# County of Fairfax, Virginia

## STAFF REPORT ADDENDUM

### SPECIAL EXCEPTION AMENDMENT APPLICATION SEA 94-P-040

**APPLICANT:** RP MRP Tysons, LLC

ULTIMATE JONES BRANCH CONNECTOR AND JONES BRANCH DR.

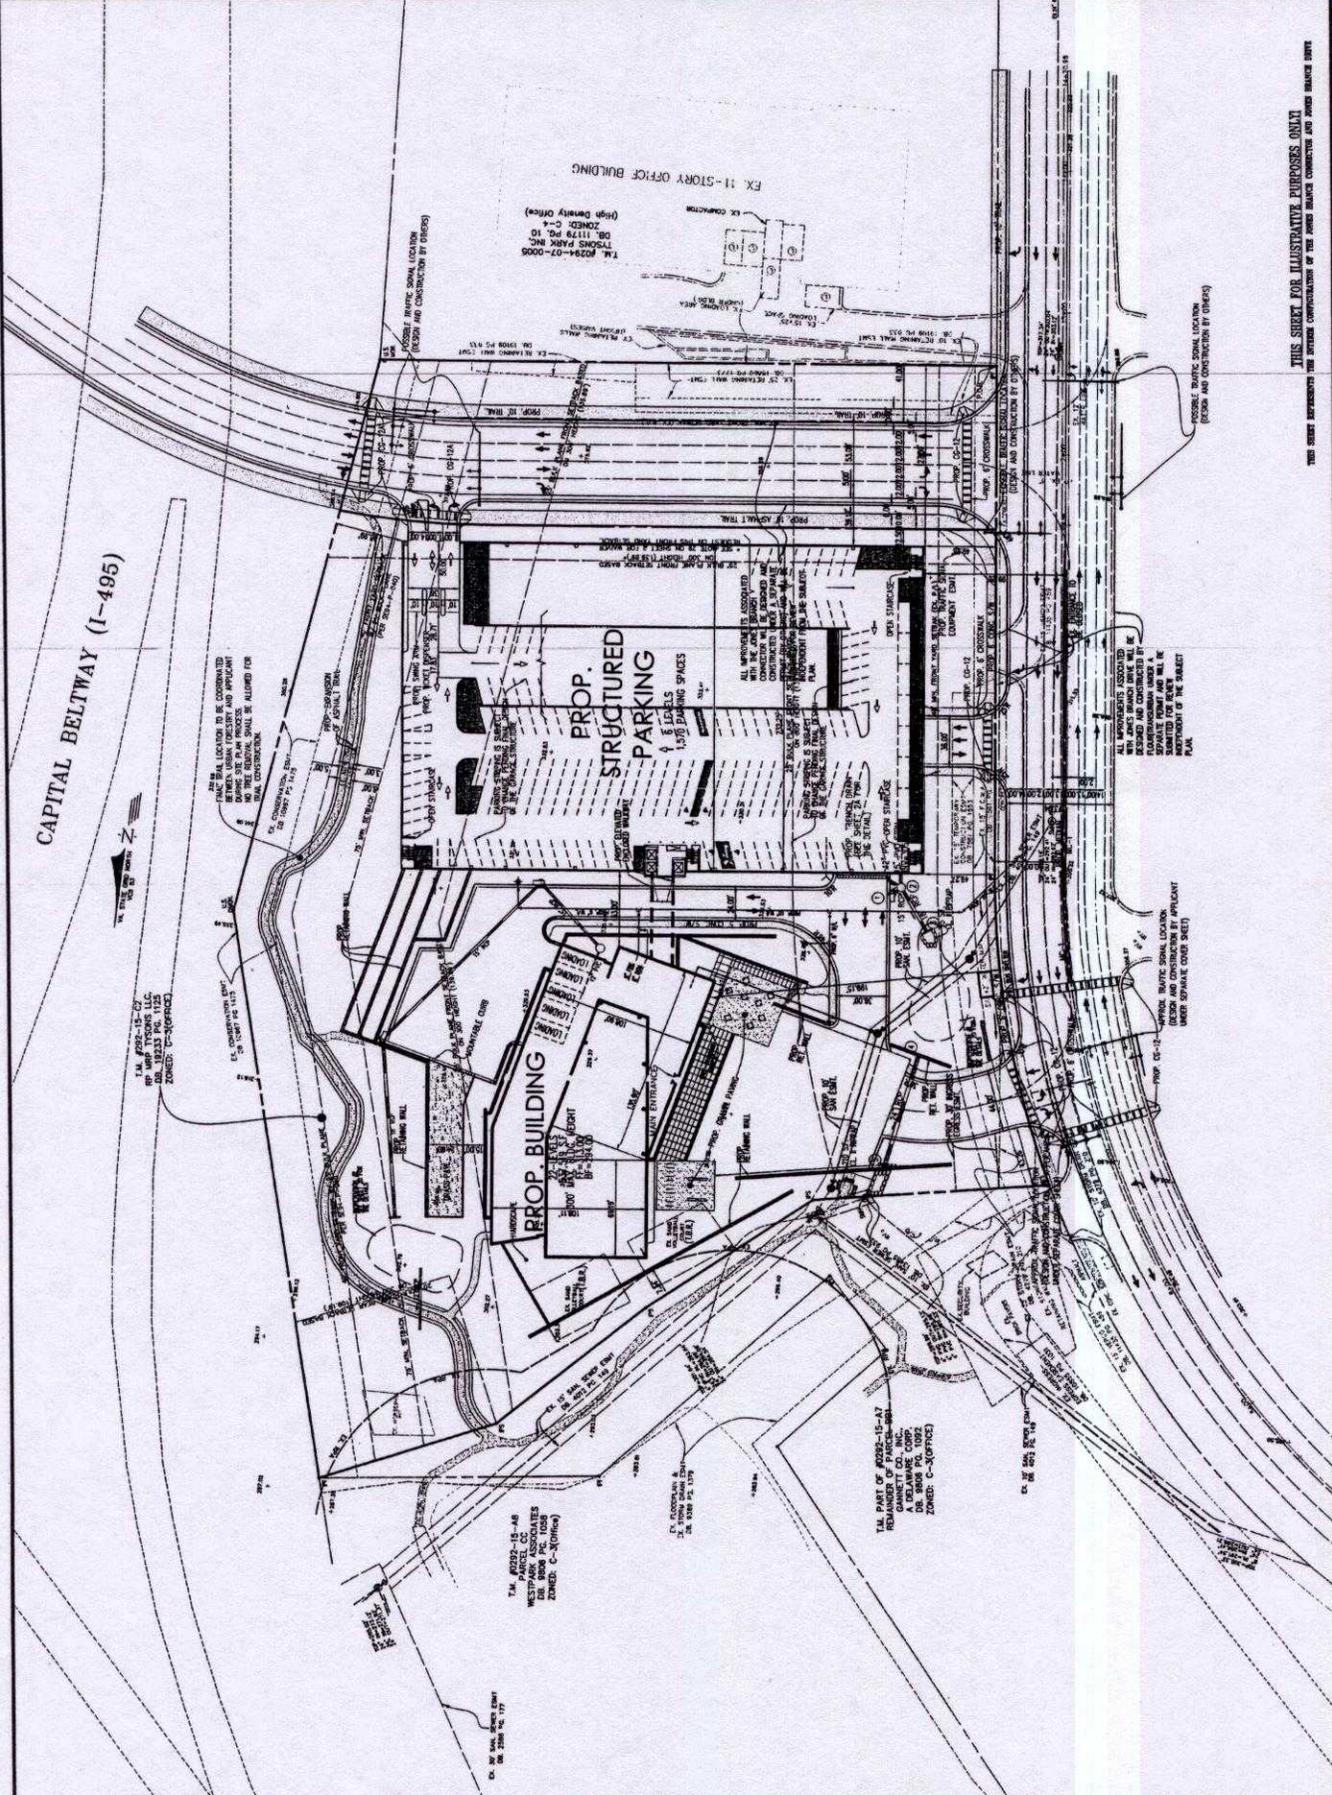
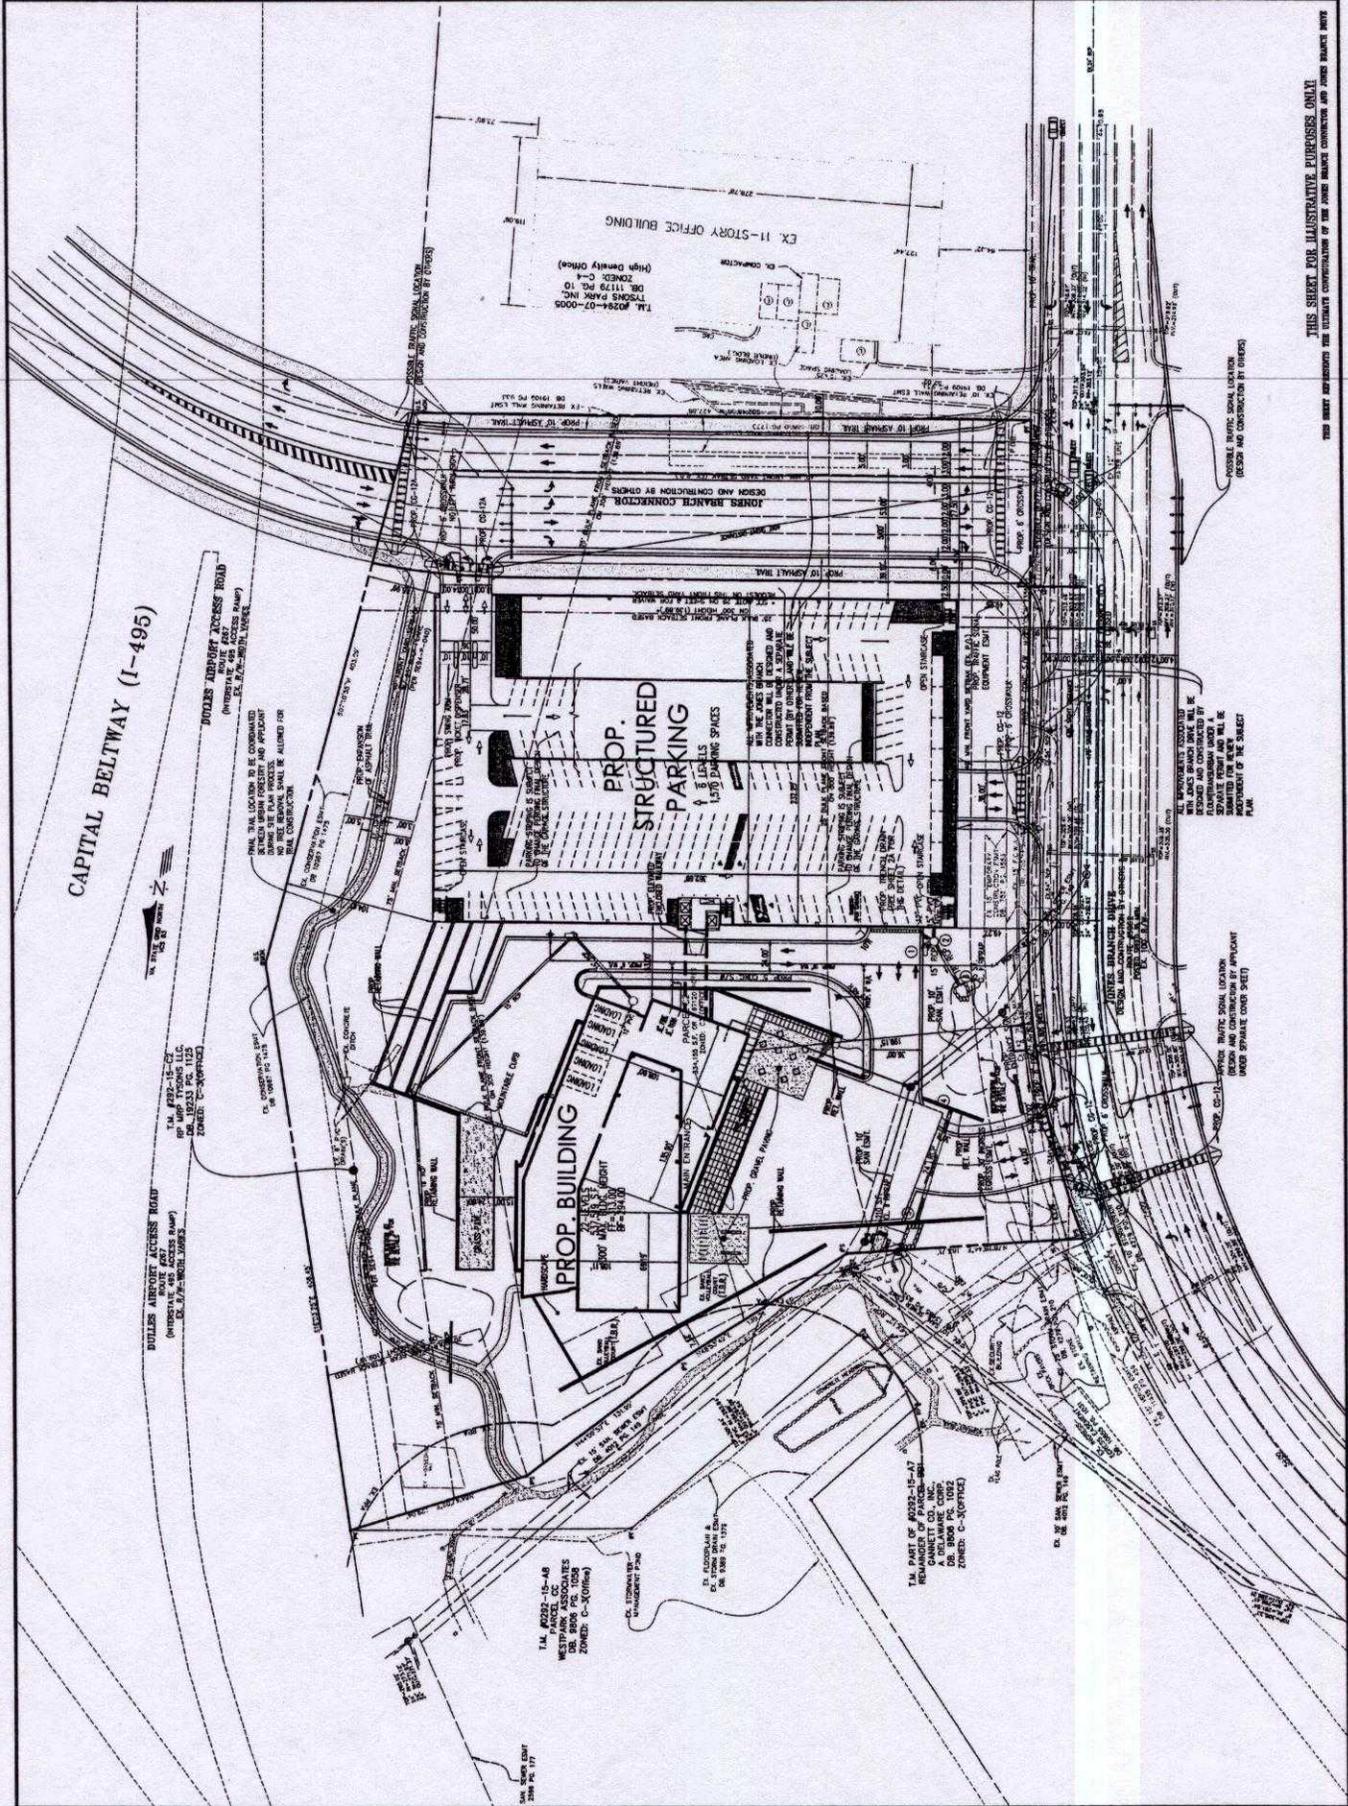
The current design of the proposed Jones Branch Connector, a critical link to the HOT Lanes to be constructed on the Capital Beltway, extends through the southern portion of the application site. The applicant continues to show the land area between the southern property line and the proposed parking garage as "reserved for future dedication" on the SEA Plat. Staff feels this area should be dedicated with this SEA Application. Staff notes that the Jones Branch Connector has the capacity to provide a very helpful link in the transportation infrastructure for Tysons Corner. In fact, the Transportation Plan shows an interchange in this area, noting the need for such a connection even without the current HOT lane project. The applicant, too, has a significant interest in not only having access generally to this new link in the road system but also in the proximity and possible direct access to the parking garage from the Jones Branch Connector. The entrance is specifically discussed below. Staff believes that dedication of this land area will enable the applicant to receive a direct benefit via a direct connection while allowing for the implementation of the transportation element of the Comprehensive Plan. This issue remains unresolved.

- iii. As determined necessary by VDOT and FCDOT at the time of site plan review, a continuous right turn lane along the Property's frontage shall be provided as shown on Sheet 7A. Should this improvement be included in the contract to construct HOT lanes improvements on Jones Branch Drive, then funds for all costs associated with this improvement shall be escrowed by the applicant as determined by DPWES. The escrow amount shall be limited to the costs associated with the actual

**3 Garage Elevation - West**  
 SCALE: 1/4"=1'-0"

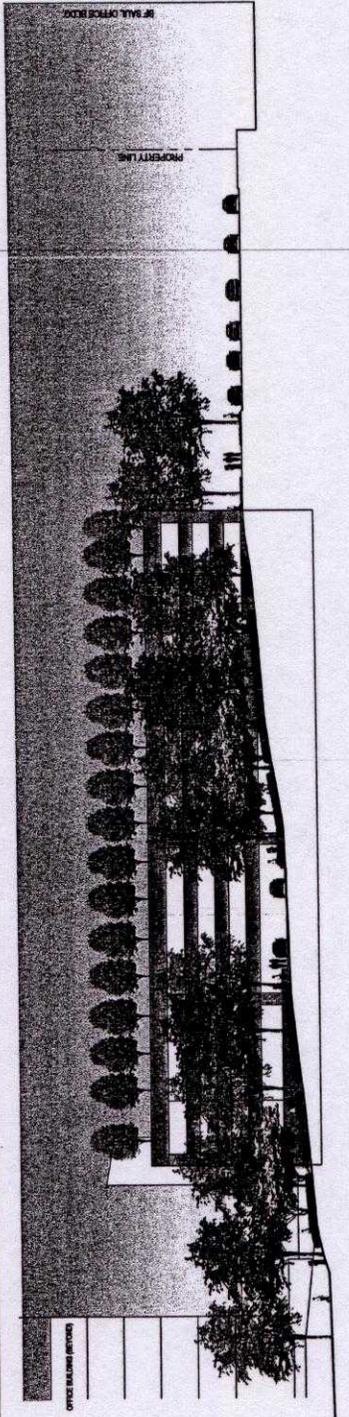
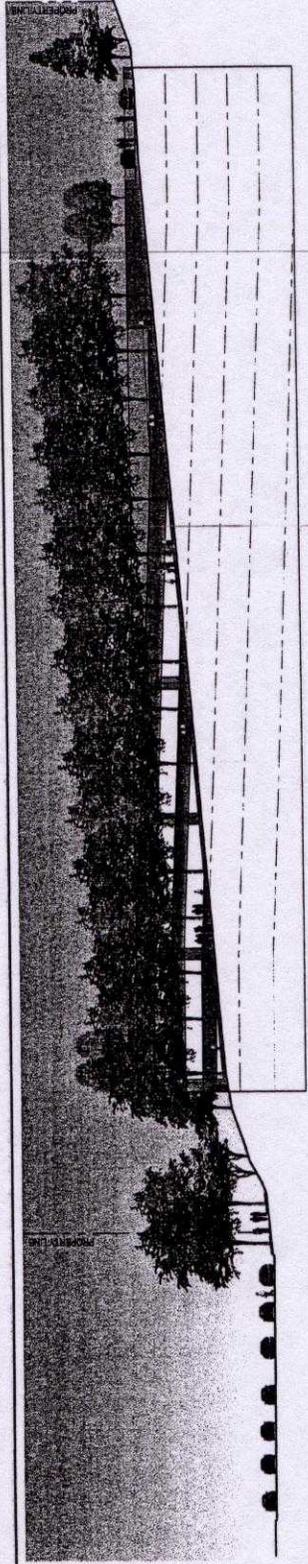
17. **Parking Structure.** The garage façade shall be constructed with high-quality architectural block, stone, stone-like material, colored pre-cast concrete or a comparable material. The garage façade shall incorporate architectural treatments such as “ribbing”, eyebrows or other details that complement the architecture of the adjacent office building. All minimum planting areas, as determined by the Public Facilities Manual (PFM), shall be met at the time of site plan review and approval for plantings proposed on the parking structure. In addition, two rows of trees shall be installed along the parking structure’s frontage on Jones Branch Drive and on the proposed Jones Branch Connector, as more particularly shown in the Garage Elevations and Sections, Sheet 13 of the SEA Plat.
